AREVA Inc. Response to Request for Public Comment on the Draft Regulatory Guides Supporting the Proposed 10 CFR 50.46c Performance-Based Emergency Core Cooling Systems Cladding Acceptance Criteria [DG-1261, "Conducting Periodic Testing for Breakaway Oxidation Behavior" (Docket ID NRC-2012-0041), DG-1262, "Testing for Post Quench Ductility" (Docket ID NRC-2012-0042), and DG-1263, "Establishing Analytical Limits for Zirconium-Based Alloy Cladding" (Docket ID NRC-2012-0043)]

AREVA Comments on 10 CFR 50.46c Proposed Rule

**AREVA Response to Proposed 10 CFR 50.46c Supplementary Information
Section VII Selected Questions**

Fig 5. Comparison of the $\alpha(O)$ layer obtained after 3270s at 1000°C in SS-FH or DS-IH conditions; (a) SEM images; (b) % $\alpha(O)$ layer deduced from SEM images analysis; (c) projected DS-FH $\alpha(O)$ layer distribution; (d) comparison between measured DS-IH and projected DS-FH

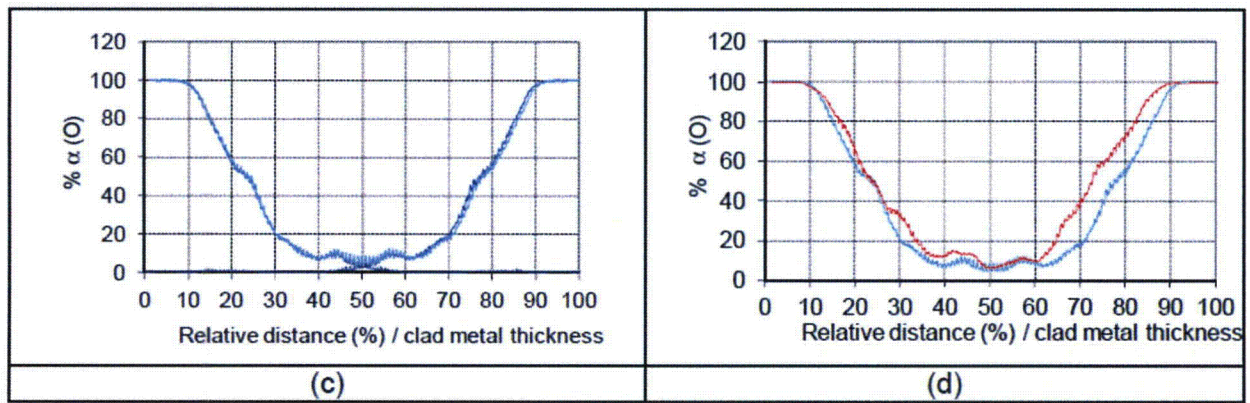
Basis for concern: As long as adequate temperature measurement and control (e.g., ramp rates) can be attained and postquench ductility is not affected by the method, the method of heating need not be specified. Previous challenges or preconceptions about the heating methods should not carry forward as prescriptions in regulatory guidance. Regardless of the heating methods, all must show thermal benchmarks.

Proposal: Recommendations for specific heating methods should be removed. Section 5.2 through 5.5 can be replaced with a single section focusing on adequate temperature control or the ability of a certain heating method to demonstrate results similar to those that are generally accepted.

Basis of proposal: Broad guidance on heating methods will encourage the development of better techniques. Furthermore, the paper, V. Vandenberghe *et al.* "Sensitivity to Chemical Composition Variations and Heating/Oxidation Mode of the Breakaway Oxidation in M5 Cladding Steam Oxidized at 1000°C (LOCA conditions)," presented at LWRFPMP, Manchester, UK, 2012 showed that the oxygen profiles were nearly identical between CINOG (induction heating) and DEZIROX (radiation heating) (see figure below). Since, for a given material and pre-hydrogen content, post-quench behavior is directly related to the prior- β thickness and oxygen content, induction heating will not impact PQD behavior.
